Glendell Mine Modification 4

RESPONSE TO SUBMISSIONS

May 2019

Project Director: Bret Jenkins
Project Manager: Penelope Williams
Report No. 4052/R11
Date: May 2019

FIGURE 6.4

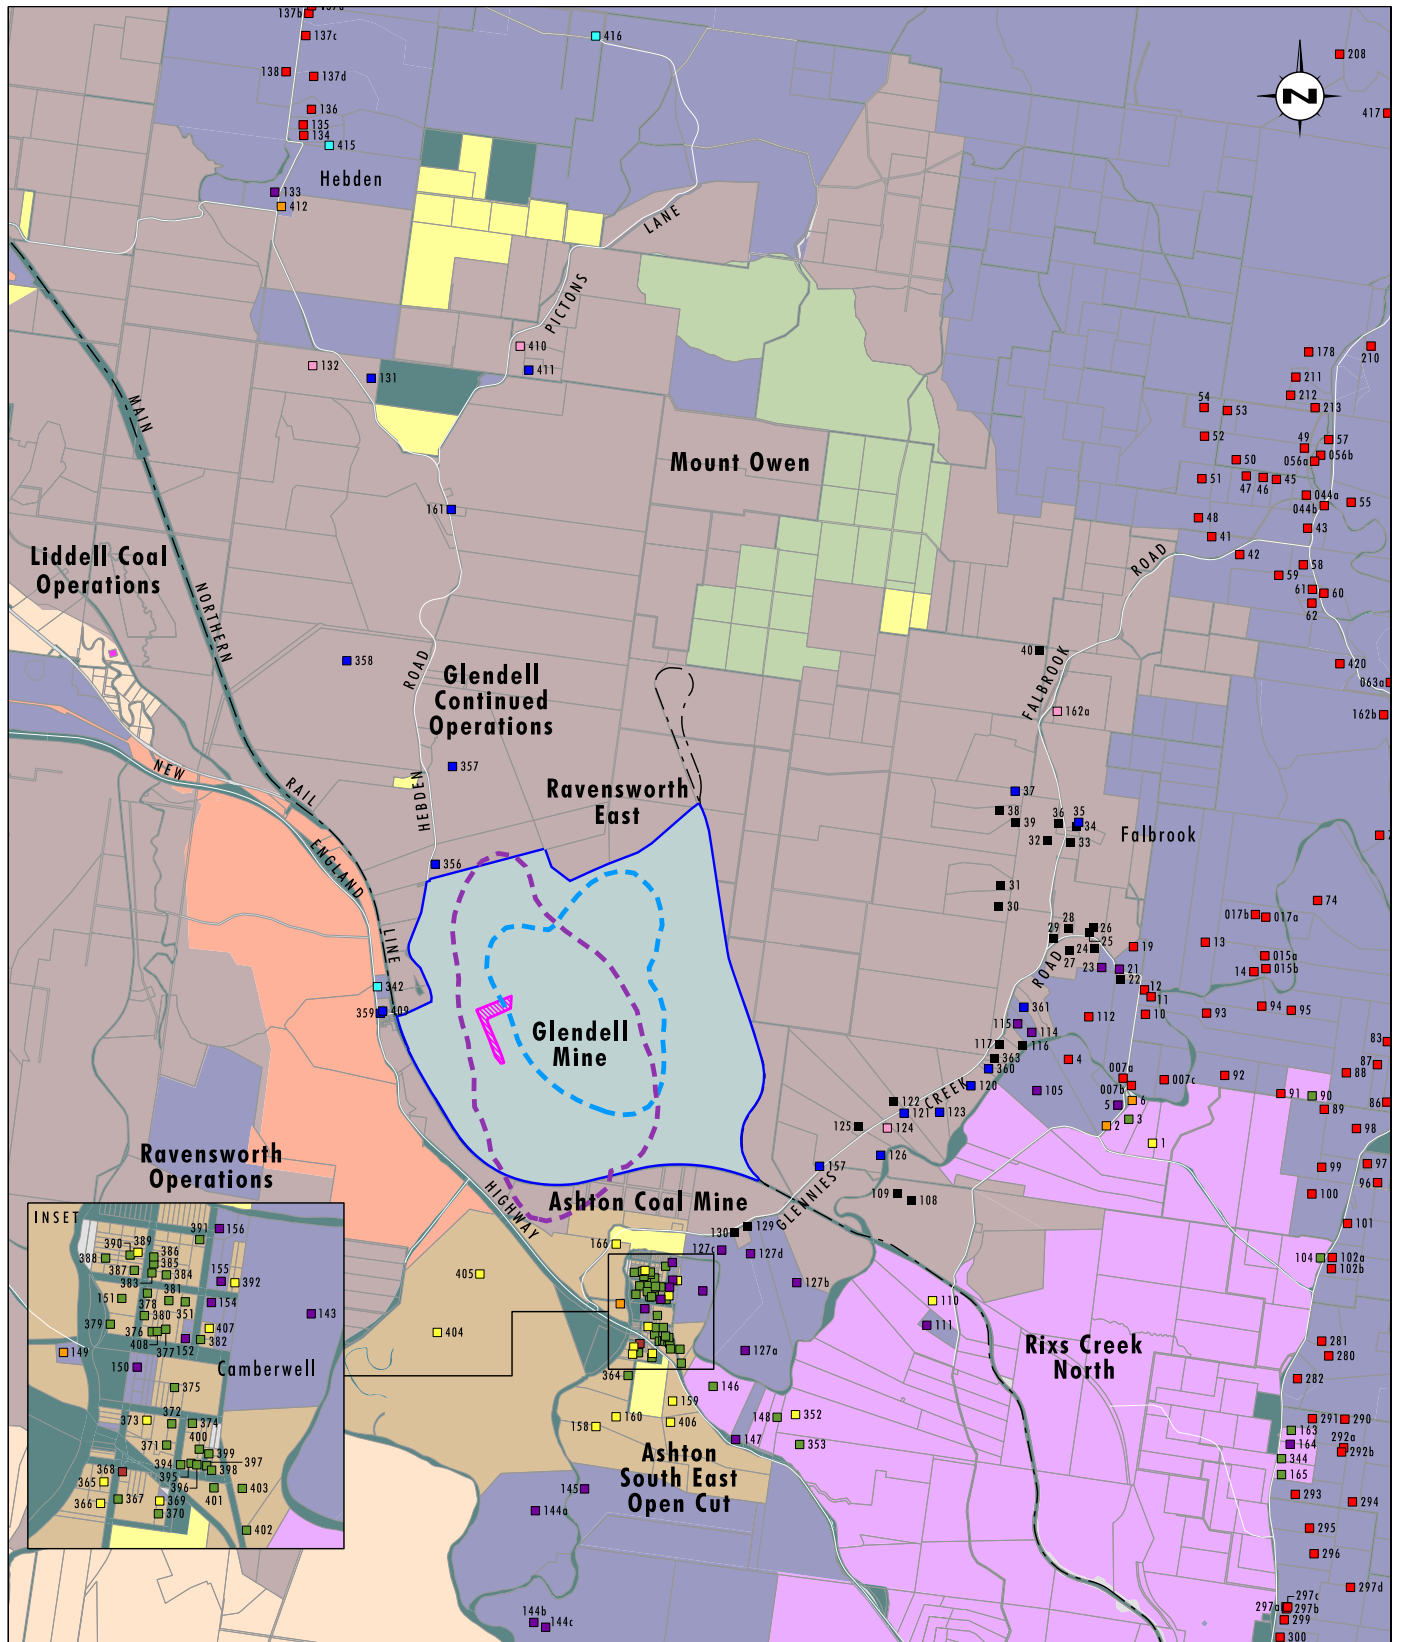
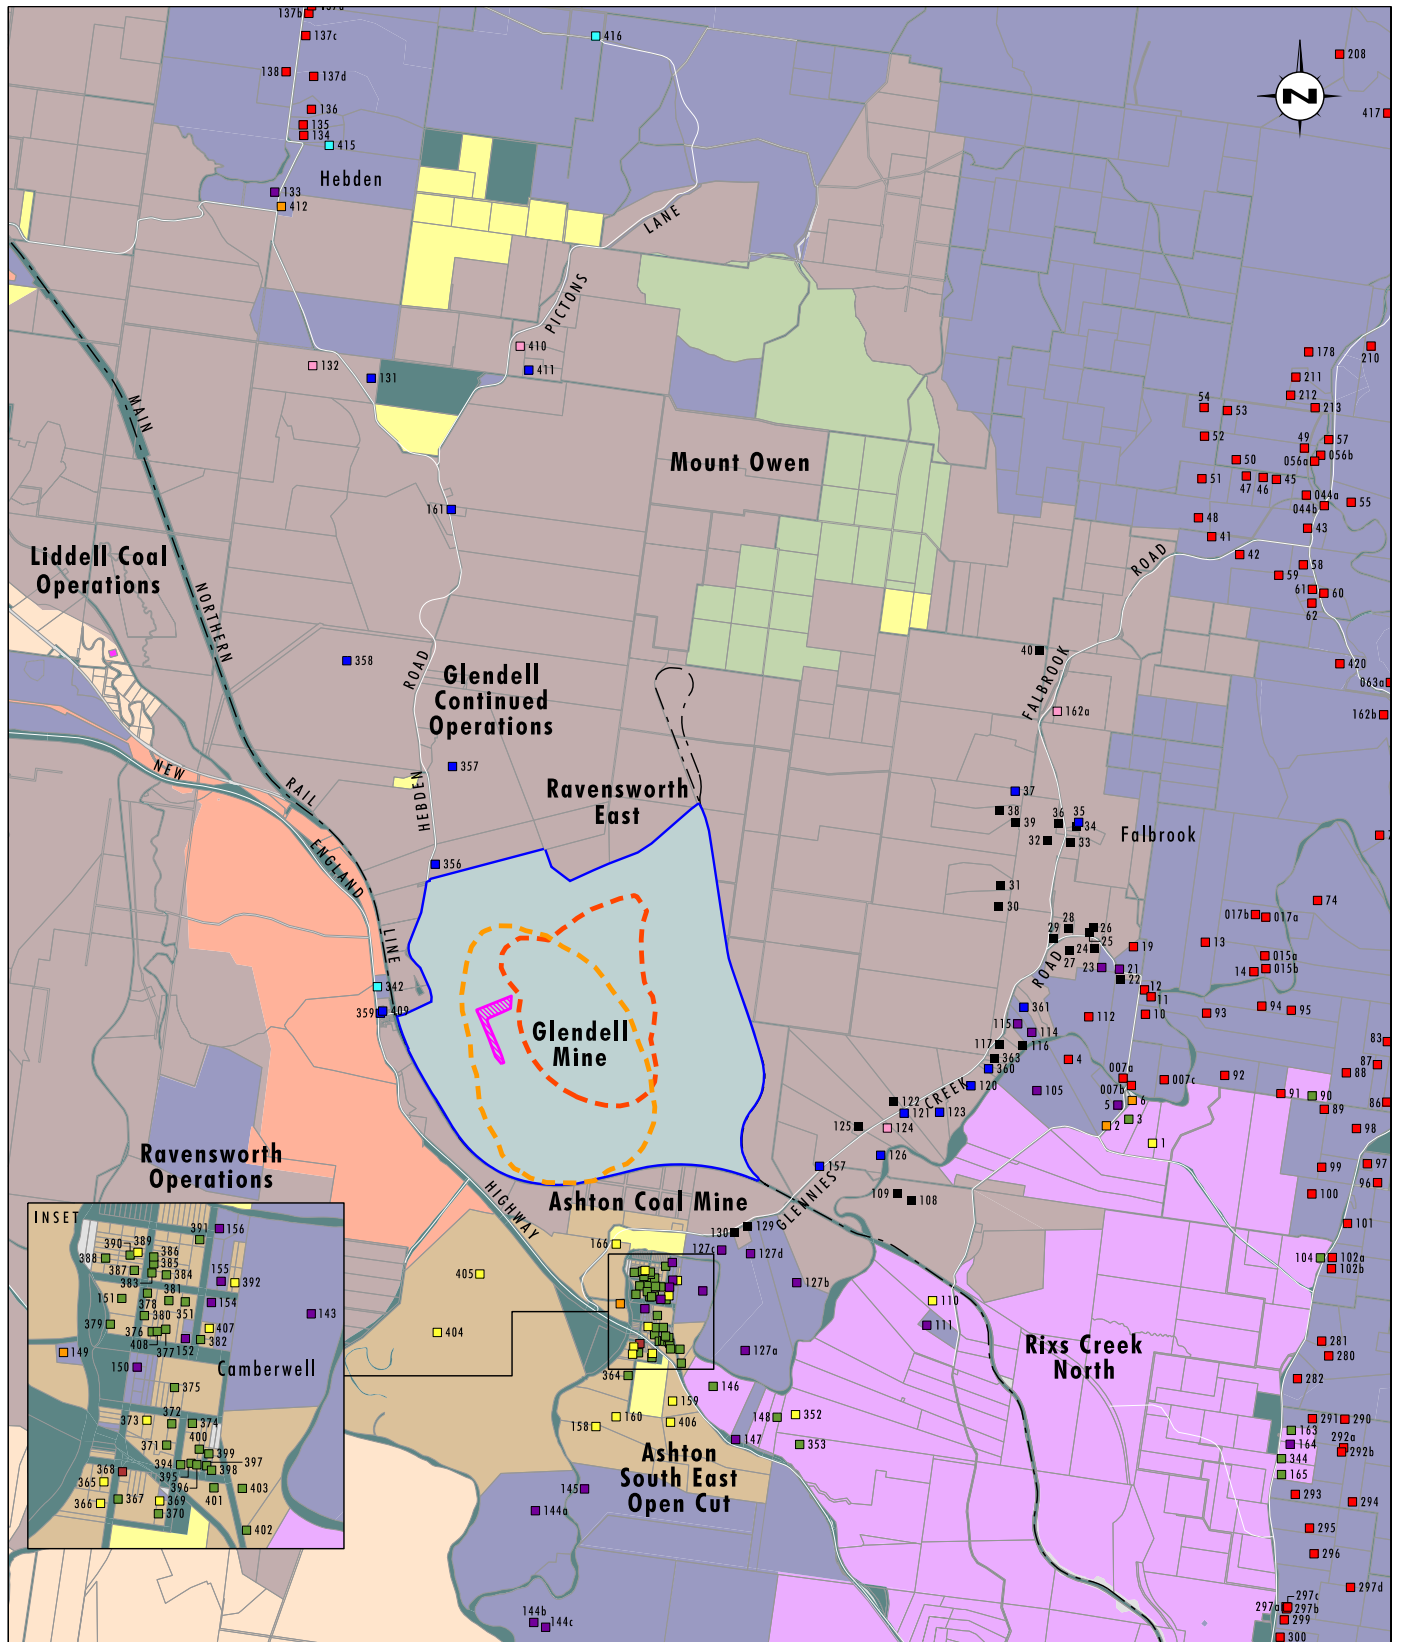
The predicted maximum 24-hour average and annual average PM_{2.5} concentrations due to the Proposed Modification are shown on **Figure 6.4** and **6.5**. As previously discussed, PM_{2.5} predictions for the Approved Operations are not available for comparison as the PM_{2.5} levels were not modelled at the time of the 2007 AQIA as the criteria were not applicable at the time, however there is no exceedance of the current criteria predicted as a result of the Proposed Modification.
